**UNITED STATES OF AMERICA
NUCLEAR REGULATORY COMMISSION
Before the Licensing Board**

In the Matter of)	Docket Nos. 52-025 COL and
SOUTHERN NUCLEAR OPERATING CO.)	52-026-COL
(Combined Operating License, Vogtle Electric)	ASLPB No. 09-873-01-COL-BD01
Generating Plant, Units 3 and 4)	October 30, 2009
)

DECLARATION OF PAULA L. FELDMAN, P.E.

ATTACHMENT B

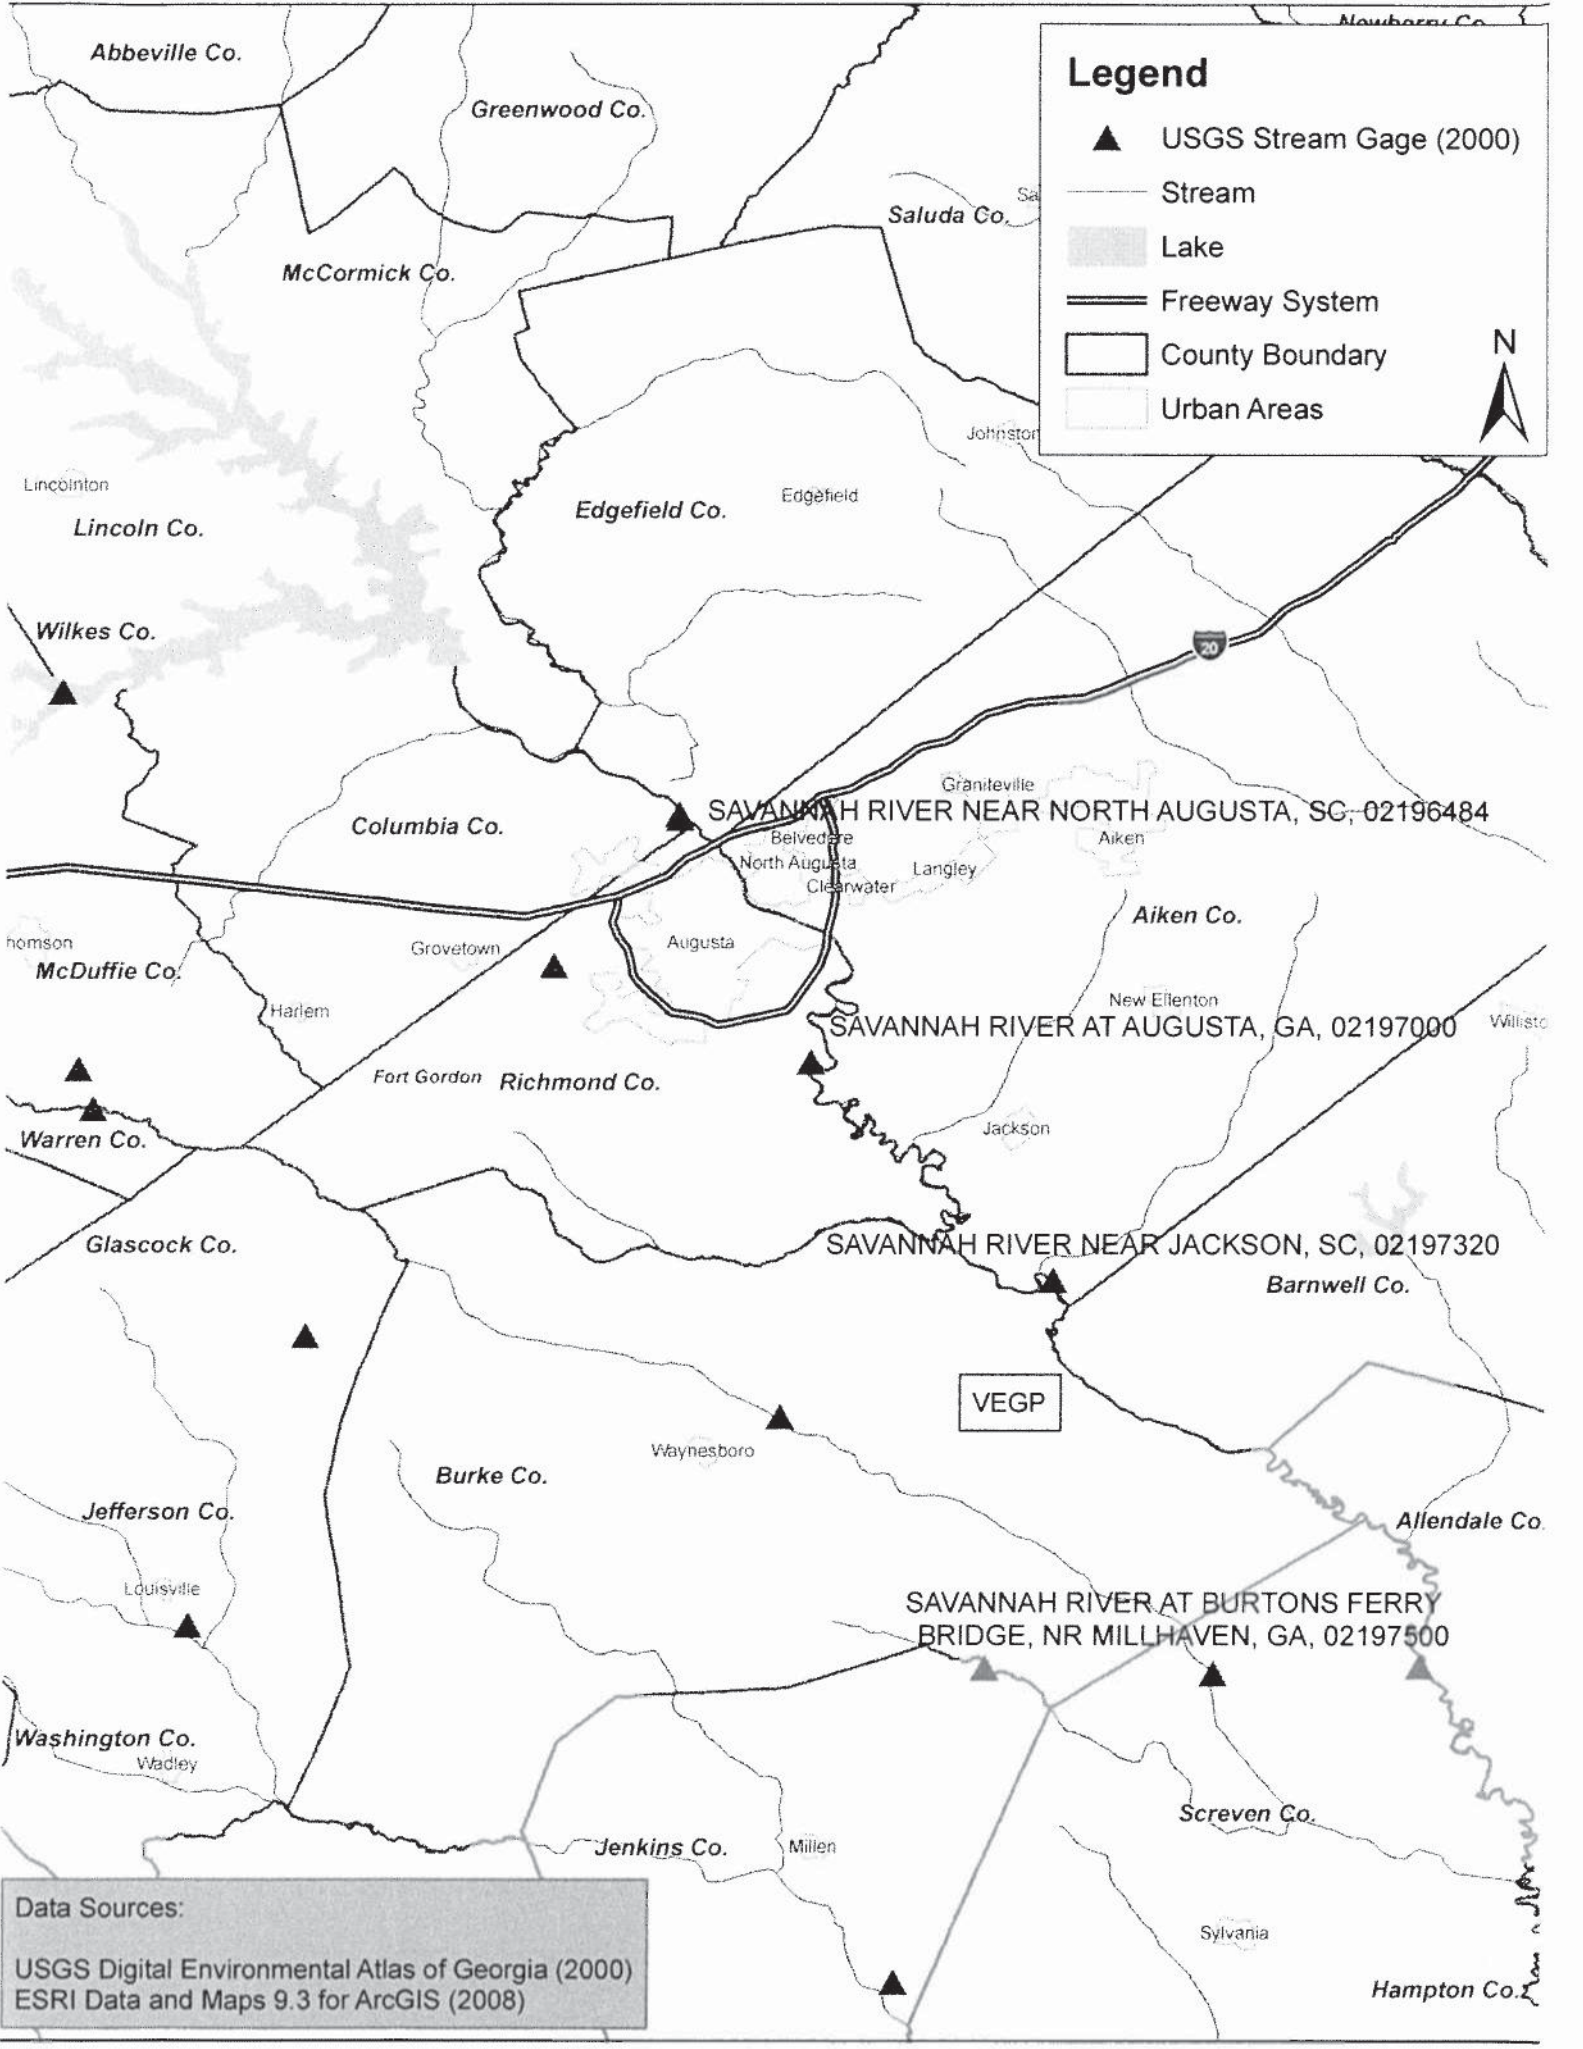
14. In fact, the "Savannah River at Augusta" gage (Gage # 02197000) is not the closest gage to the Vogtle site. It lies about 34 river miles upstream of Vogtle. Another gage, known as "Savannah River Near Jackson," is located closer to Vogtle, only six

miles upstream of the Vogtle plant. (Gage # 02197320).⁷ See Attachment B hereto, based on USGS stream gage data taken from “Digital Environmental Atlas of Georgia,” Georgia Geologic Survey Publication CD-1, Version 2 published by USGS (2002). Historical flow data from the closer gage more accurately determines potential impacts of the Vogtle plant. At this location, the 7Q10 flow as determined by the Georgia Environmental Protection Division’s Watershed Protection Branch (“EPD-WPB”) is 4070 cfs, not 3800 cfs.⁸ Thus, even if one could assume that river flows at the gage nearest Vogtle plant would “rarely” drop below 3800 cfs when releases from Thurmond Dam decrease to 3100 cfs, those river flows would be more than 200 cfs below the 7Q10 flow required at the to protect the Savannah River and its resources. (It also says nothing about what the river flows near Vogtle would be if discharges from Thurmond Dam drop to 2600 cfs, as is contemplated by the Corps’ Flow Reduction Plan).
